INDIANA DEPARTMENT OF TRANSPORTATION

APPROVED MINUTES

September 21, 2017 Standards Committee Meeting
(Changes (see minutes from the November 15, 2017 meeting) to the Final Draft shown as highlighted in yellow)

RE: Minutes from the September 21, 2017 Standards Committee Meeting

PROPOSED NEW RPD 801-T-2XXd NEXT LEVEL ROADS SIGN (REVISED DRAFT)

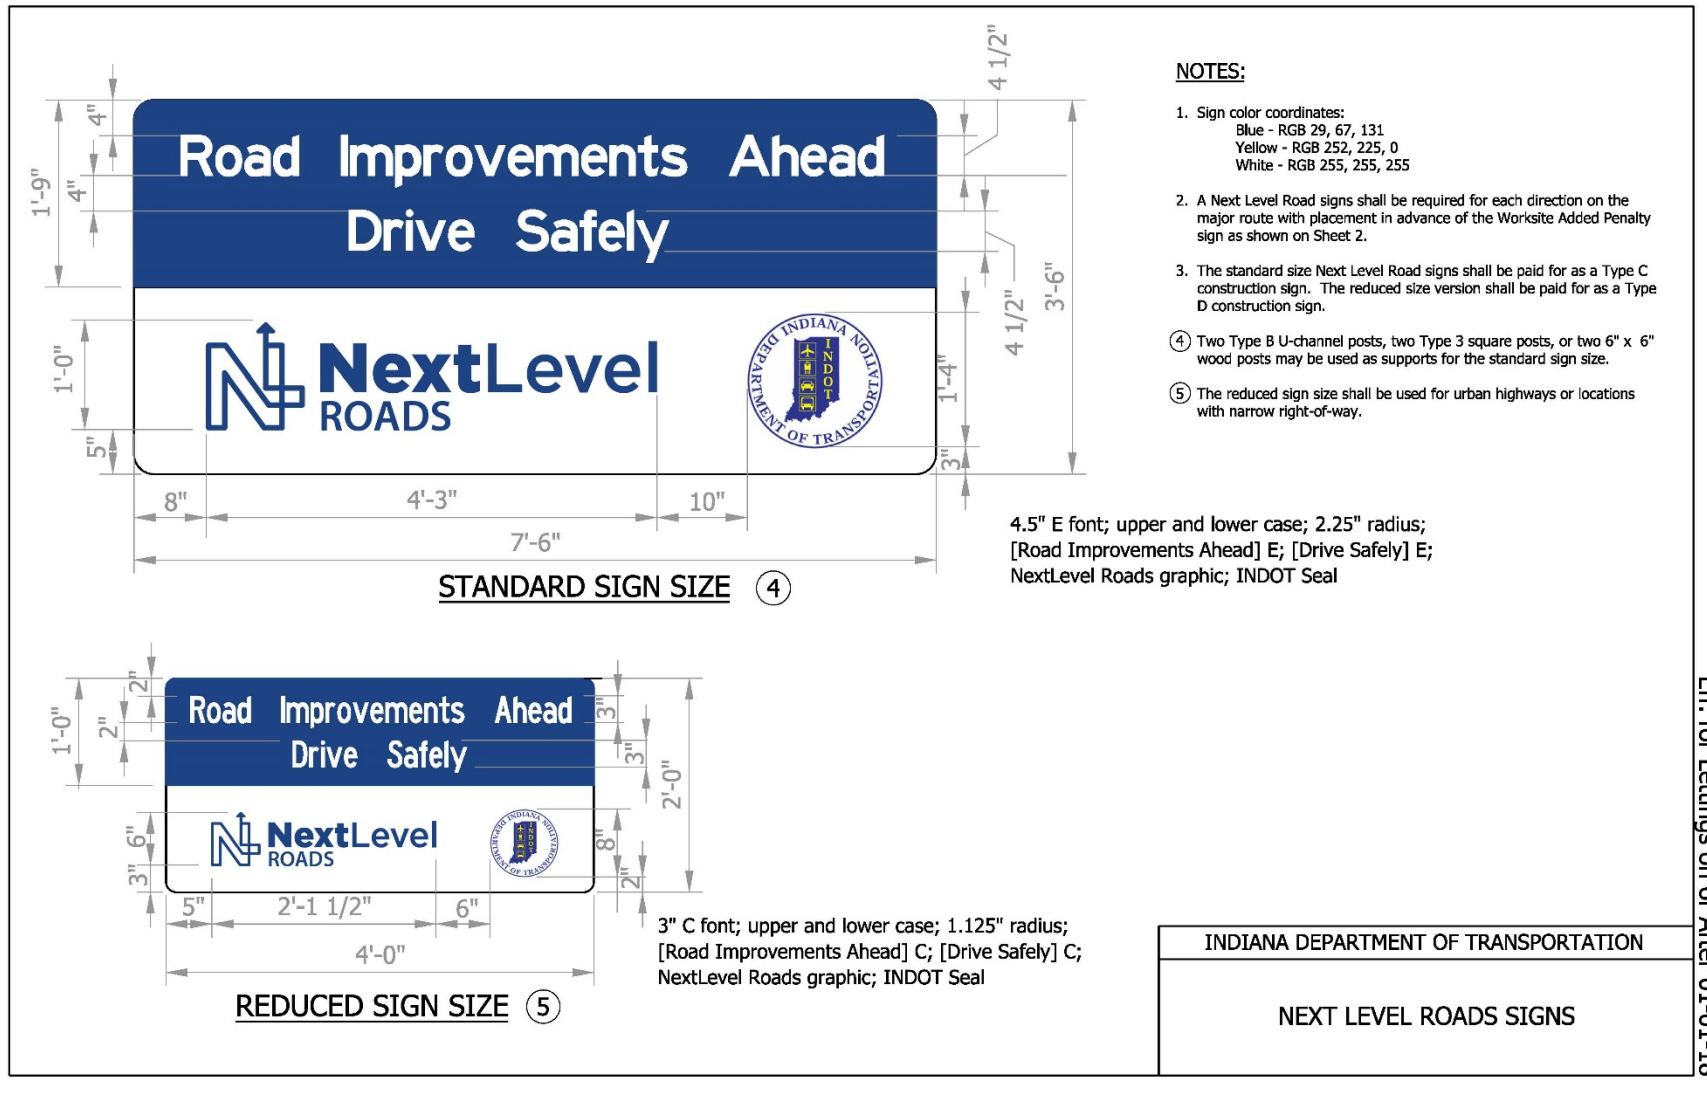
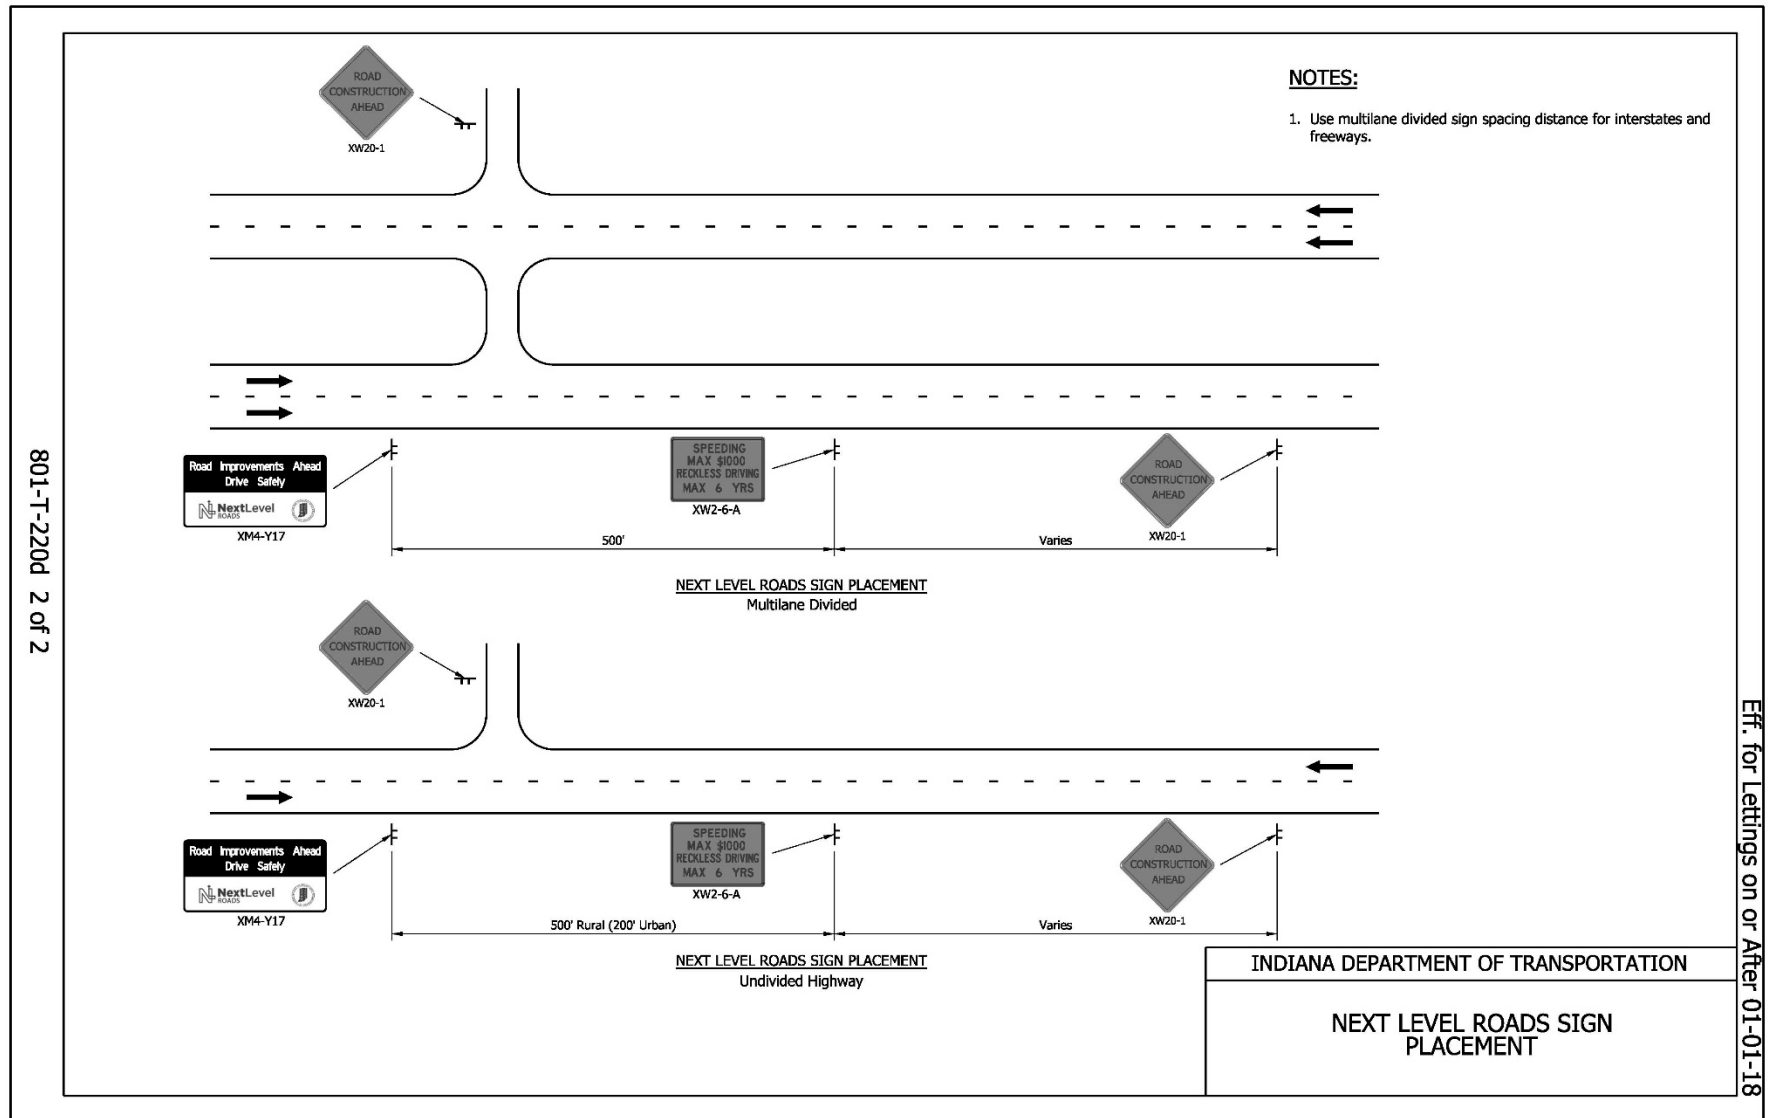
This item was introduced and presented by Mr. Boruff who explained that the Governor's Office has requested information signs to identify Next Level Roads projects. Mr. Boruff proposed to create a recurring plan detail with sign shop drawings and typical placement locations. The sign design was developed by the Department's Central Office and is as shown above.

Mr. Osborn expressed concern over the type of sign this will be and if it can be properly manufactured. Mr. Bruno offered solutions to those concerns, and will provide revisions accordingly.

Mr. Boruff revised his motion.
